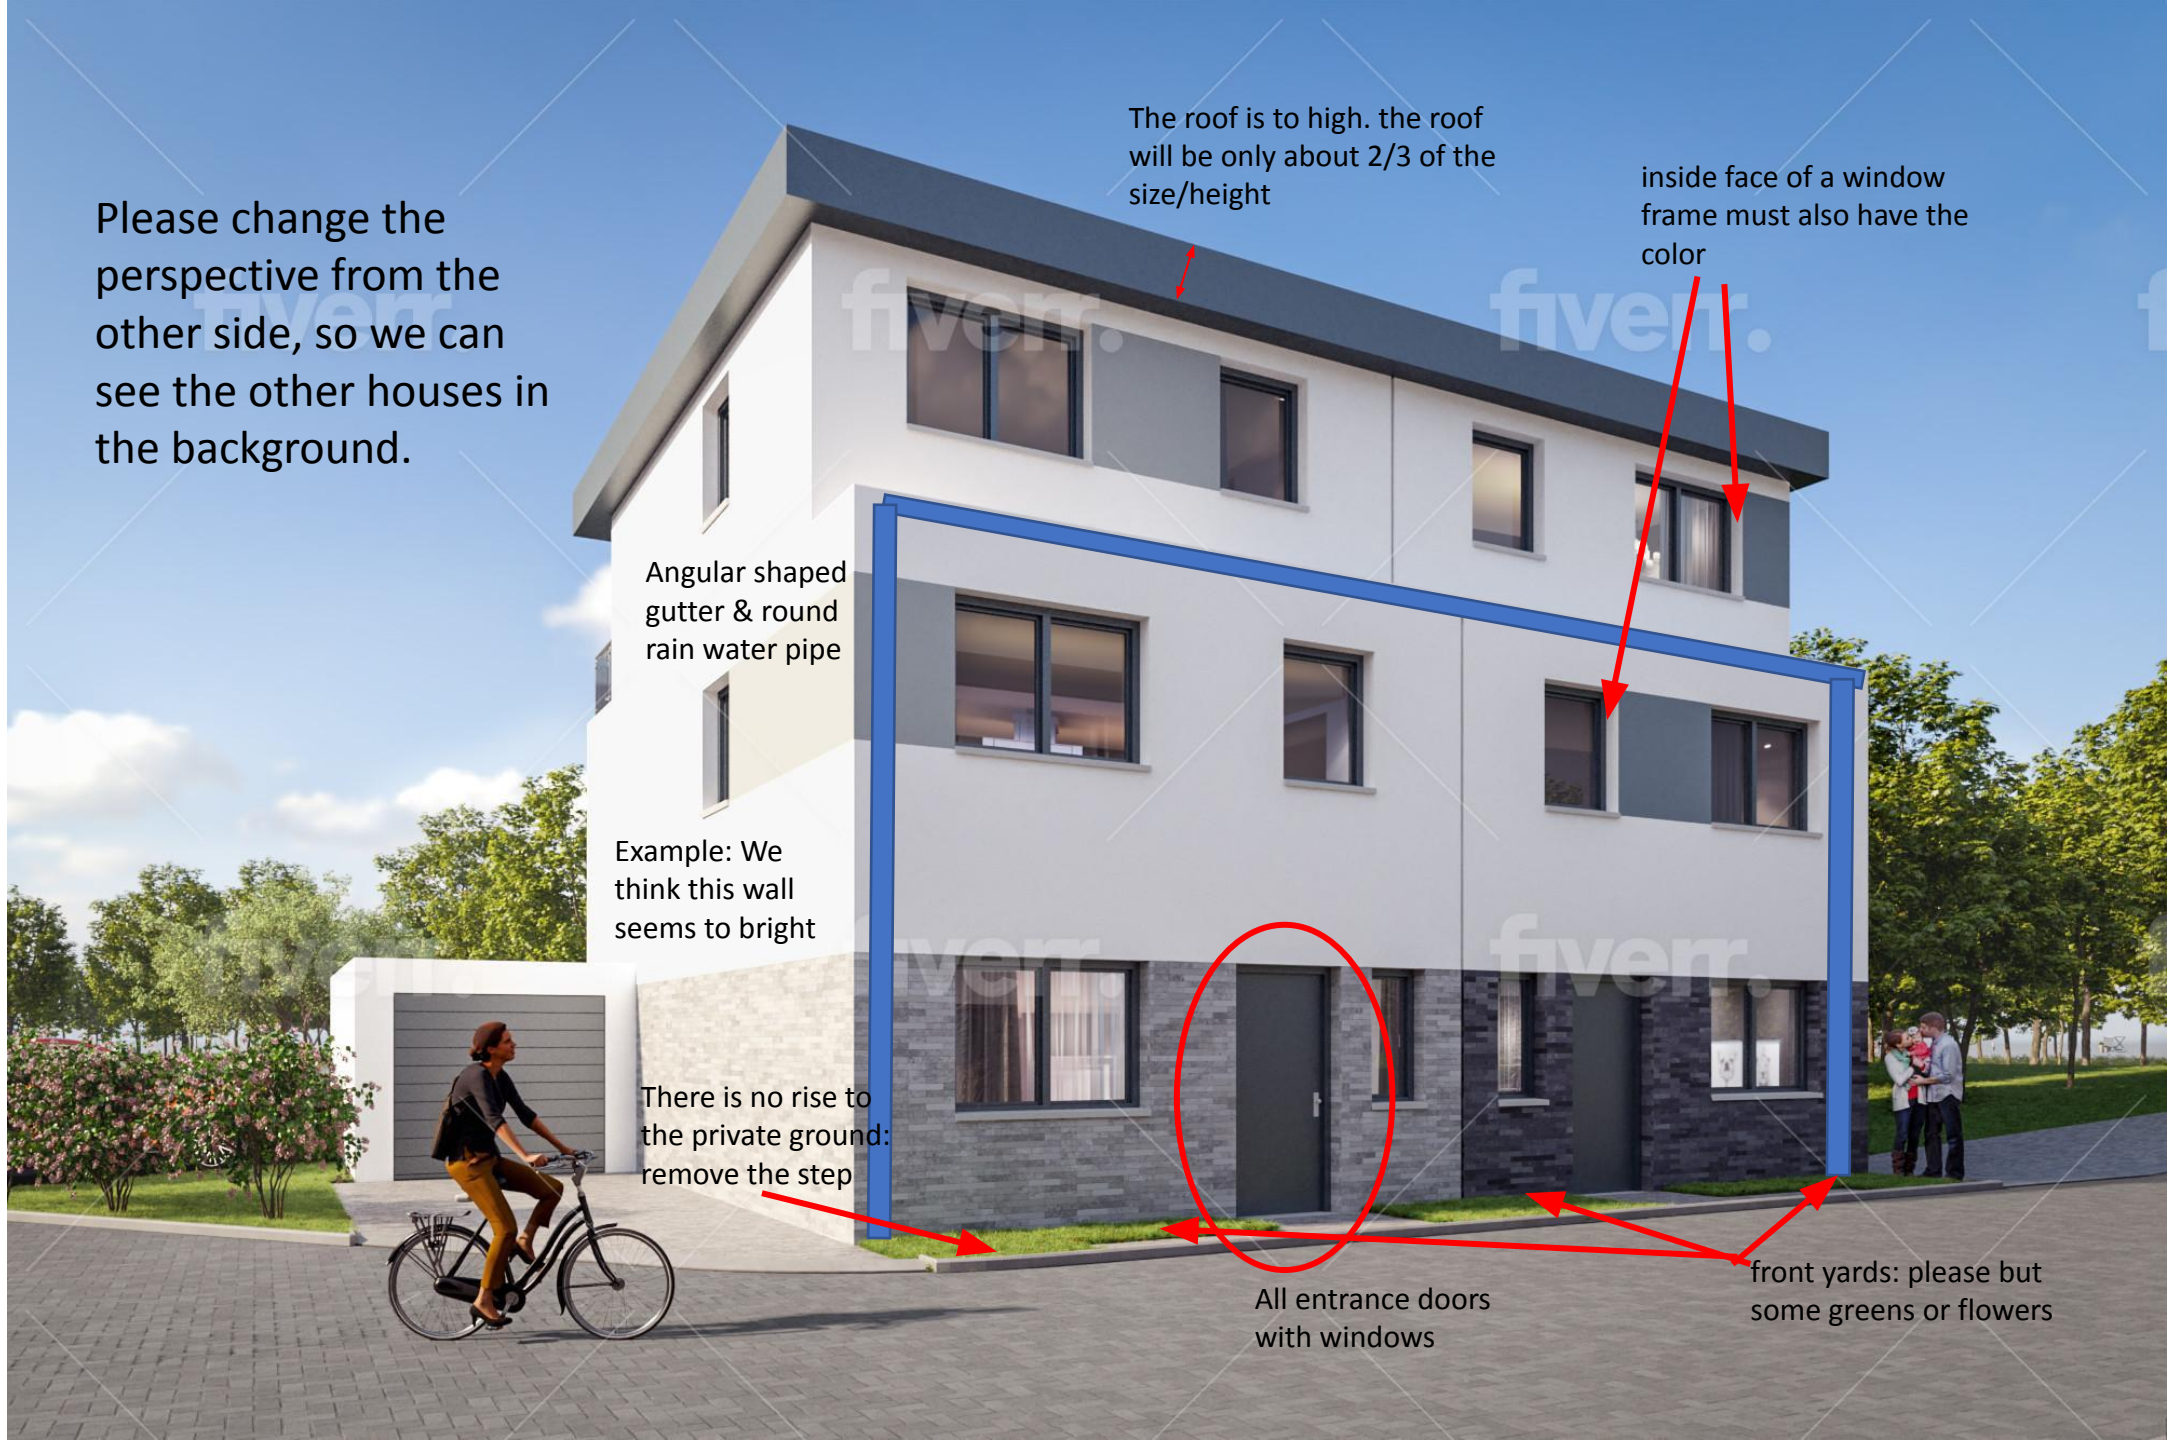
Please change the perspective from the other side, so we can see the other houses in the background.

The roof is too high. the roof will be only about 2/3 of the size/height

inside face of a window frame must also have the color

Angular shaped gutter & round rain water pipe

Example: We think this wall seems to bright

There is no rise to the private ground: remove the step

All entrance doors with windows

front yards: please but some greens or flowers

Please change the perspective: a little higher... we do not like the sharp angle of the roof (top, left)

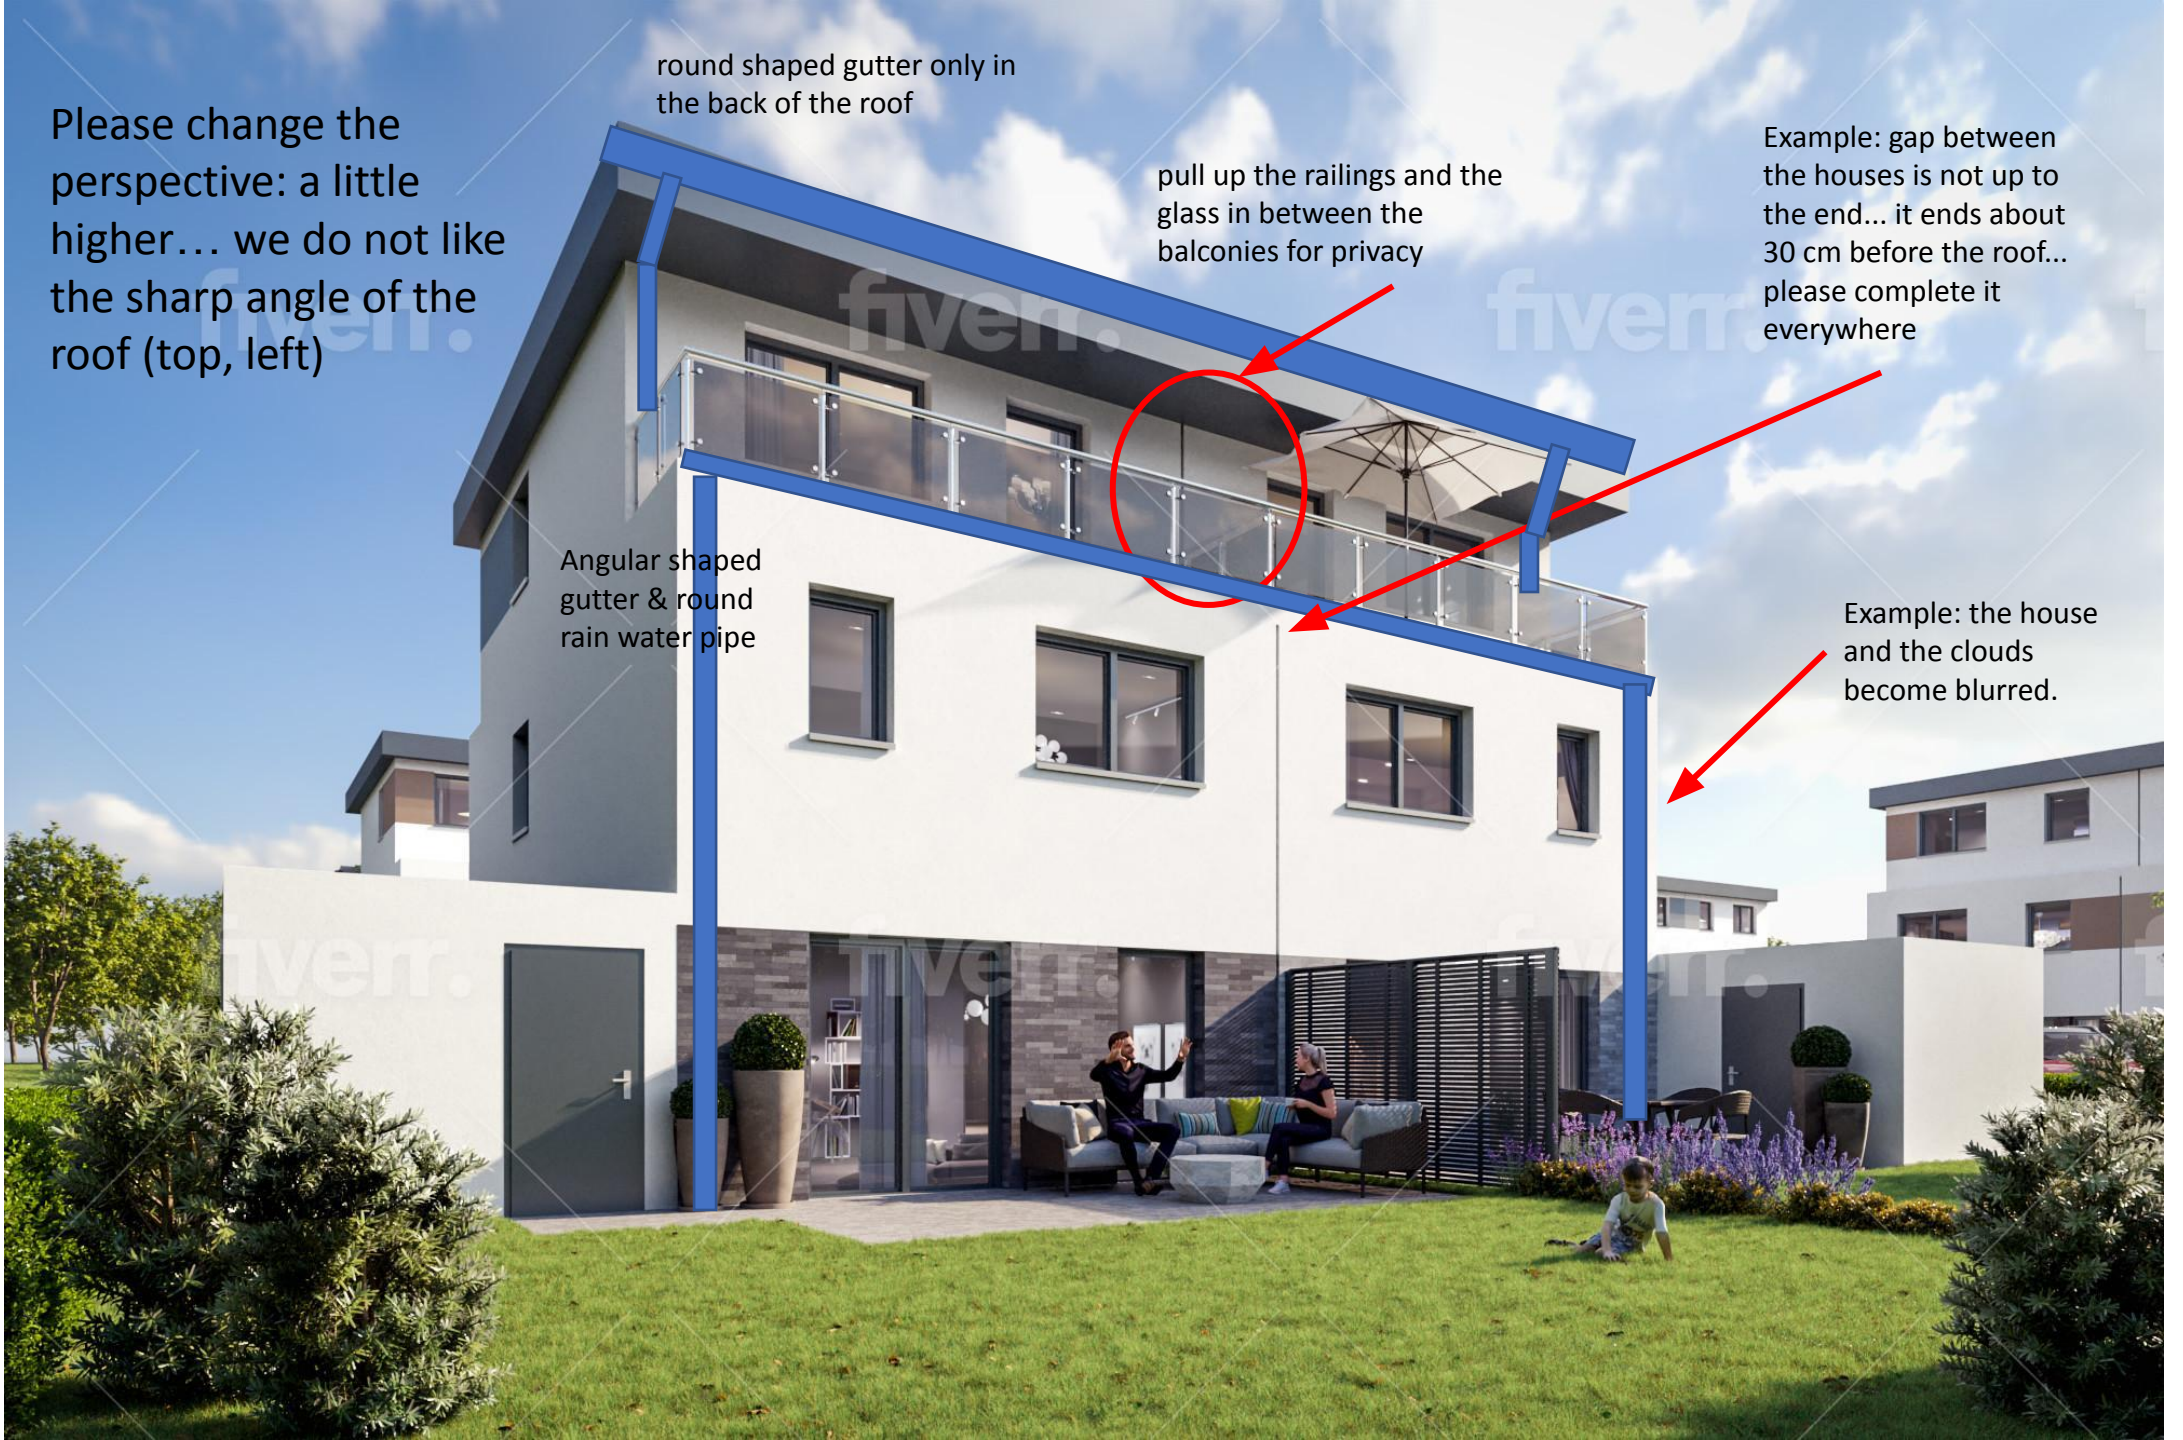
round shaped gutter only in the back of the roof

pull up the railings and the glass in between the balconies for privacy

Example: gap between the houses is not up to the end... it ends about 30 cm before the roof... please complete it everywhere

Angular shaped gutter & round rain water pipe

Example: the house and the clouds become blurred.

Put some big trees (blue circles) on the border of the property, so it looks not so empty.. Like here:

the bound in front of the single-family houses must be anthracite grey, like you did already with the multi-family houses.

So empty, please park a car or some people...

Strange line on the edge

Street ends here...

Hedge must be on the private ground, so more to the right side.

A small linden tree here

No curbstone please. This is to wide and to high... we will have a 8 cm wide border stone but same height as plaster

No border here in front of parking slots

Please change the perspective: a little higher... we do not like the sharp angle of the roof (top, left)

round shaped gutter & round rain water pipe

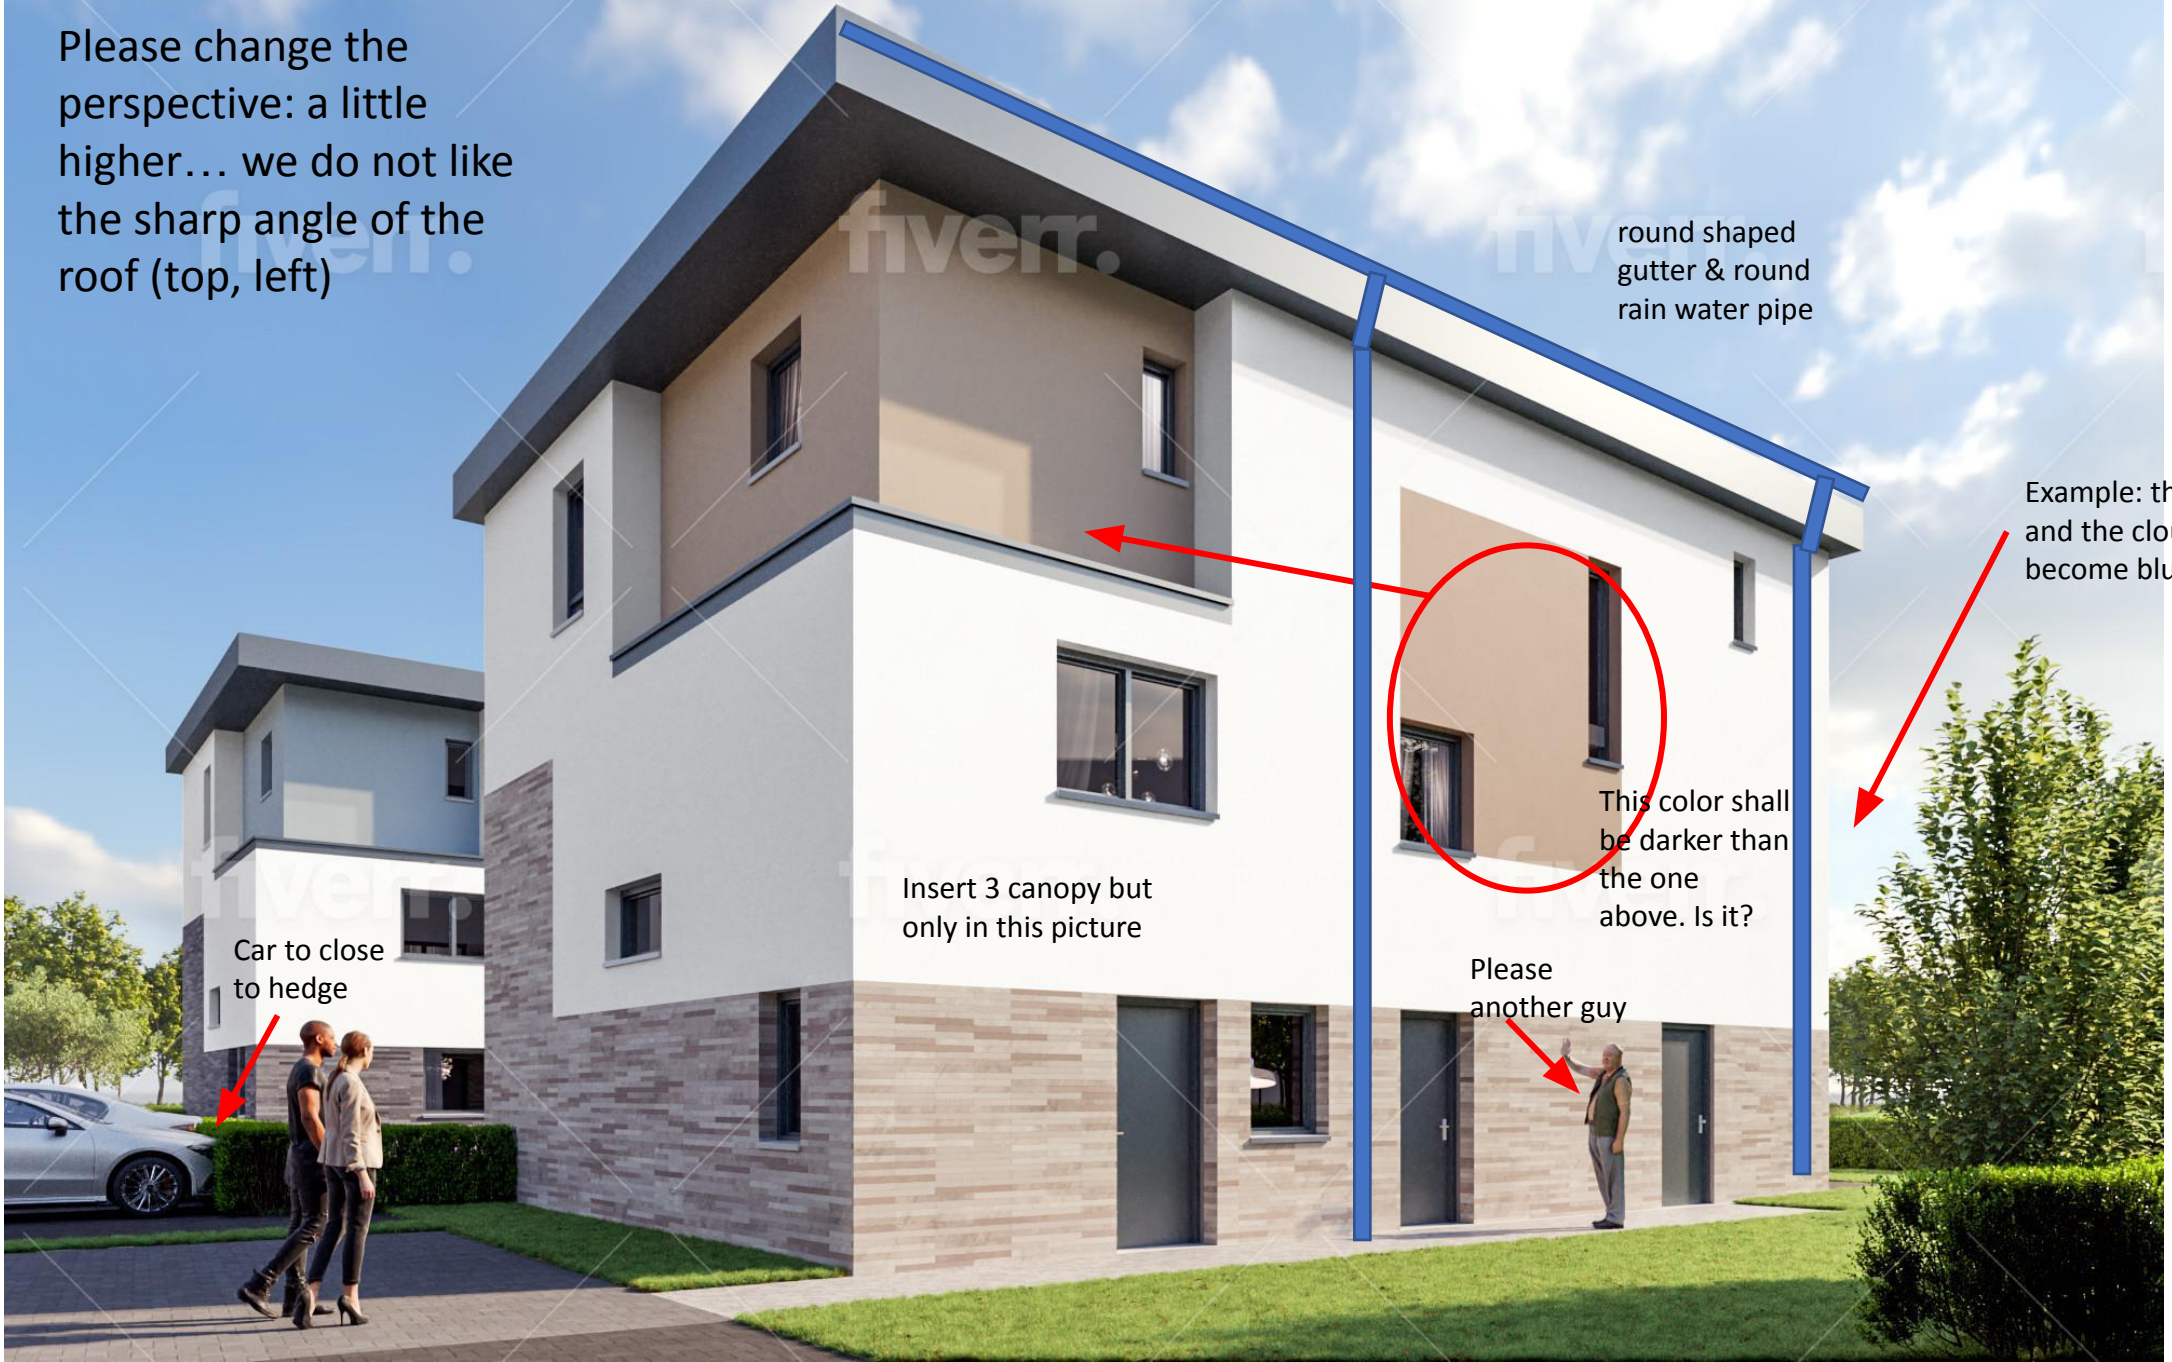
Example: the house and the clouds become blurred

This color shall be darker than the one above. Is it?

Insert 3 canopy but only in this picture

Please another guy

Car to close to hedge

Please change the perspective: a little higher... we do not like the sharp angle of the roof (top, left)

pull up the railings and the glass in between the balconies for privacy

inside face of a window frame must also have the clinker

Angular shaped gutter & round rain water pipe

Instead of privacy screen: concrete wall 20 cm width with bricks (5 cm attic in anthracit). height: same as windows

Please change the perspective: a little higher... we do not like the sharp angle of the roof (top, left)

round shaped gutter & round rain water pipe

Strange line on the edge

Angular shaped gutter & round rain water pipe

The colors of the brick seem so different, to the colors in the front, adapt the lighting please

inside face of a window frame must also have the color

The shade is so strong...it looks like these are different colors.

This arrangement of colors is wrong, the blue color begins here.

Angular shaped gutter & round rain water pipe

put the bicycle on the public street

No curbstone please. This is to wide and to high... we will have a 8 cm wide border stone but same height as plaster

Please but here a car...and move the lady and her pet to the right...
